Work Order ID 129091

Item Name: Replacement Skidtube, Low & High Gear with Standard Wearplates Fits LH or RH

DRAWING NO. D2650	TITLE 206/407 SKIDTUBE ASSEMBLIES	REV. F	DART AEROSPACE LTD ENGINEERING ORDER		D.E.O. NO. D2650-F-1	SHEET NO. SHEET 1 OF 1	SCALE NTS
DRAWN <i>[Signature]</i>	CHECKED A.P.	MFG. APPR. <i>[Signature]</i>	APPROVED <i>[Signature]</i>		DE APPR. <i>[Signature]</i>		
DATE 12.10.12	DATE 12.10.22	DATE 12.10.22	DATE 12.10.22		DATE 12.10.22

DETAIL G

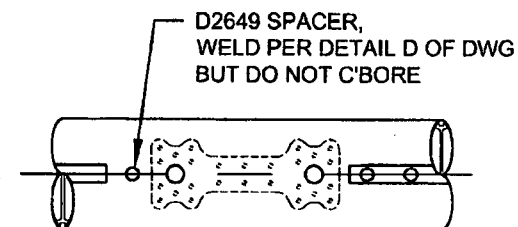
ADD DETAIL G BELOW, WHICH IS THE SAME SECTION VIEW AS DETAIL D OF DWG.

C'BORED HOLES ARE **NOW SWAGED** PER DETAIL G BELOW. FOR THE Ø0.375 HOLE THAT IS NOT C'BORED, WELD PER DETAIL D OF DWG (SEE AMENDED DETAIL B FOR REFERENCE).
